E/ECE/324 }  
E/ECE/TRANS/505 } Rev.1/Add.82/Rev.3/Amend.3

#### **Addendum 82: Regulation No. 83**

#### **Revision 3 - Amendment 3**

### **UNIFORM PROVISIONS CONCERNING THE APPROVAL OF VEHICLES WITH REGARD TO THE EMISSION OF POLLUTANTS ACCORDING TO ENGINE FUEL REQUIREMENTS**

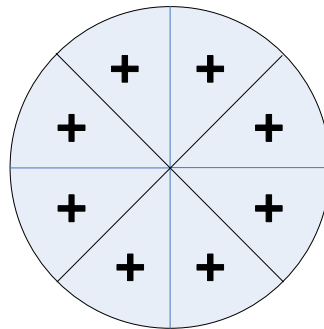
Paragraph 6.1.3., amend to read:

"6.1.3. A current of air of variable speed shall be blown over the vehicle. The blower speed shall be within the operating range of 10 km/h to at least 50 km/h, or as an alternative, at the request of the manufacturer, within the operating range of 10 km/h to at least the maximum speed of the test cycle being used. The linear velocity of the air at the blower outlet shall be within  $\pm 5$  km/h of the corresponding roller speed within the range of 10 km/h to 50 km/h. At the range over 50 km/h, the linear velocity of the air shall be within  $\pm 10$  km/h of the corresponding roller speed. At roller speeds of less than 10 km/h, air velocity may be zero.

The above mentioned air velocity shall be determined as an averaged value of a number of measuring points which:

- (a) For blowers with rectangular outlets are located at the centre of each rectangle dividing the whole of the blower outlet into 9 areas (dividing both horizontal and vertical sides of the blower outlet into 3 equal parts);
- (b) For circular blower outlets, the outlet shall be divided into 8 equal arcs by vertical, horizontal and 45° lines. The measurement points lie on the radial centre line of each arc (22.5°) at a radius of two thirds of the total (as shown in the diagram below).

Each value at those points shall be within 10 per cent of the averaged value of themselves.

The device used to measure the linear velocity of the air shall be located at between 0 and 20 cm from the air outlet.

The final selection of the blower shall have the following characteristics:

- (i) Area: at least 0.2 m<sup>2</sup>;
- (ii) Height of the lower edge above ground: approximately 20 cm;
- (iii) Distance from the front of the vehicle: approximately 30 cm.

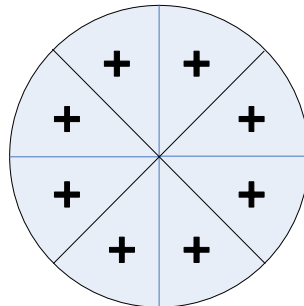
Paragraph 3.4.2., amend to read:

"3.4.2. A current of air of variable speed shall be blown over the vehicle. The blower speed shall be, within the operating range of 10 km/h to at least 50 km/h, or as an alternative, at the request of the manufacturer within the operating range of 10 km/h to at least the maximum speed of the test cycle being used. The linear velocity of the air at the blower outlet shall be within  $\pm 5$  km/h of the corresponding roller speed within the range of 10 km/h to 50 km/h. At the range over 50 km/h, the linear velocity of the air shall be within  $\pm 10$  km/h of the corresponding roller speed. At roller speeds of less than 10 km/h, air velocity may be zero.

The above mentioned air velocity shall be determined as an averaged value of a number of measuring points which:

- (a) For blowers with rectangular outlets are located at the centre of each rectangle dividing the whole of the blower outlet into 9 areas (dividing both horizontal and vertical sides of the blower outlet into 3 equal parts).
- (b) For circular blower outlets, the outlet shall be divided into 8 equal arcs by vertical, horizontal and  $45^\circ$  lines. The measurement points lie on the radial centre line of each arc ( $22.5^\circ$ ) at a radius of two thirds of the total (as shown in the diagram below).

Each value at those points shall be within 10 per cent of the averaged value of themselves.

The device used to measure the linear velocity of the air shall be located at between 0 and 20 cm from the air outlet.

The final selection of the blower shall have the following characteristics:

- (i) Area: at least  $0.2 \text{ m}^2$ ;
- (ii) Height of the lower edge above ground: approximately 0.2 m;
- (iii) Distance from the front of the vehicle: approximately 0.3 m.
